ENVIRONMENTAL REVIEW TEAM REPORT
ON
WINDHAM HILL
ASHFORD AND WILLINGTON, CONNECTICUT
NOVEMBER, 1973

ENVIRONMENTAL REVIEW TEAM REPORT
ON
WINDHAM HILL
ASHFORD AND WILLINGTON, CONNECTICUT

WINDHAM HILL, FIRST PHASE OF DEVELOPMENT

WINDHAM HILL PRELIMINARY SCHEME OF DEVELOPMENT FOR FIRST PHASE

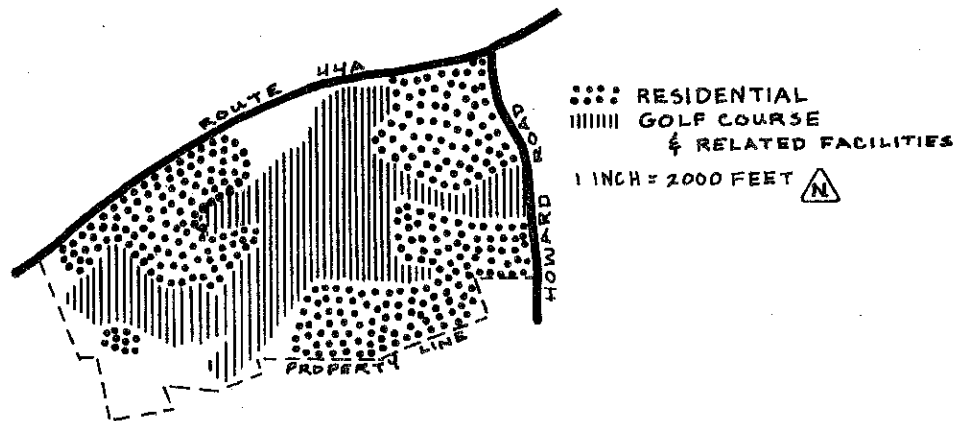
About thirty percent of the soils of the first phase fall under the inland wetlands classification as defined by P.A. 155. The golf course, as proposed, overlaps a substantial portion of this area. Besides the regulatory problems of P.A. 155, the extensive and elaborate drainage system and the fill that would be necessary to establish the golf course present serious questions as to the practicality and economic feasibility of the golf course.

In general, the concept of a combined golf course and residential development appears to be a good one. In this particular case, however, the intensity of development proposed for this site should be reevaluated with respect to its location within a water supply watershed and its relation to substantial wetland areas.

The generation of large amounts of traffic onto Howard Road should be discouraged due to its dangerous intersection with Route 44A. The plan as presently designed indicates that a large number of homes on the Ashford side of the development might be serviced by Howard Road. More convenient access to Route 44A would be preferable.

It does not appear practical or economically feasible to install a golf course as now proposed. A substantial portion of the golf course is located on poorly or very poorly drained soils that are designated as inland wetlands under P.A. 155. To develop a golf course that skirts a wetland could be both feasible and practical, but to develop a golf course through a wetland presents severe drainage and runoff problems that would be costly to correct. It should also be noted that fill over the wetland would also quickly become saturated unless the area is under-drained correctly.
